SERVICE BULLETIN 45

SUBJECT: POSSIBLE INCORRECT RUDDER PEDAL CENTER SUPPORT BRACKET

APPLICATION: All Glasair II RG aircraft shipped prior to 10/21/87

FIGURE (1)

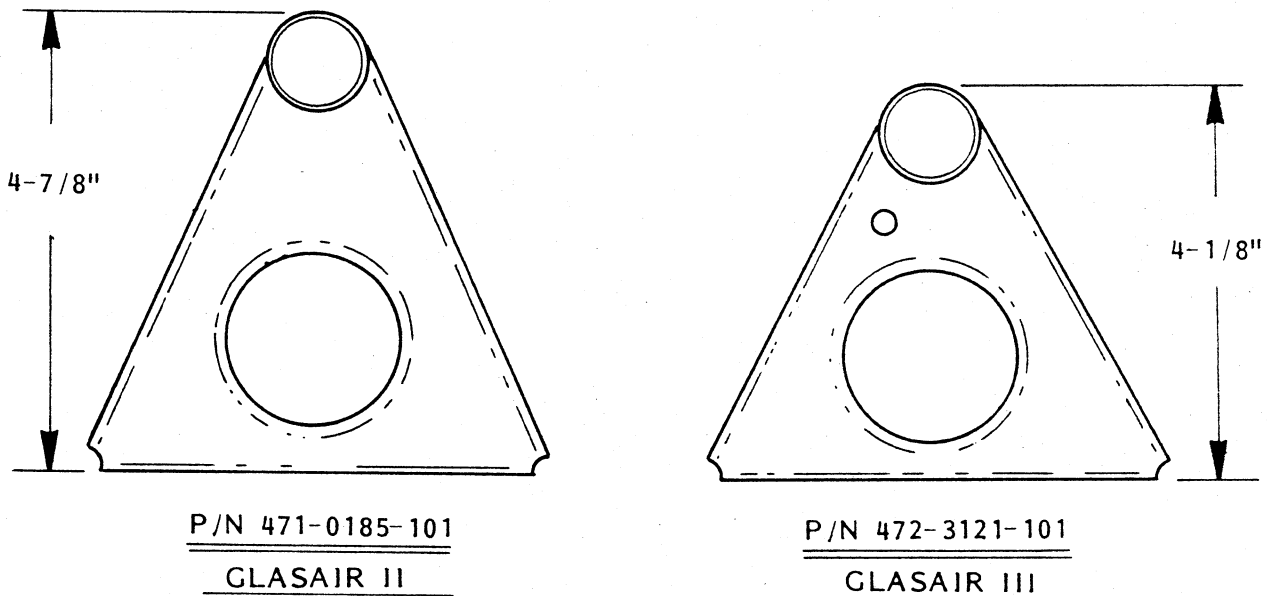
DESCRIPTION: Glasair II RG kits shipped prior to 10/21/87 may have incorrectly included a Glasair III rudder pedal center support bracket rather than the Glasair II RG center support bracket. The support bracket for the Glasair III (P/N 472-3121-101) looks similar, but is approximately 3/4" shorter than the bracket for the Glasair II (P/N 471-0185-101). The difference in height is due to the different sizes of the nose landing gear boxes on which the brackets are mounted. Use of the shorter (P/N 472-3121-101) bracket on the Glasair II will result in reduced rudder pedal clearance from the upper surface of the forward belly panel.

SOLUTION: Check the rudder pedal center support bracket supplied with your kit against the dimensions provided in FIGURE (1). If you have received the incorrect center support bracket (P/N 472-3121-101), return it to Stoddard-Hamilton Aircraft's Shipping department by 12/31/87 and the correct (P/N 471-0185-101) center support bracket will be sent to you.

NOTE: If you have already installed the rudder pedal assembly using the shorter center support bracket, contact our Builder Support department for assistance.
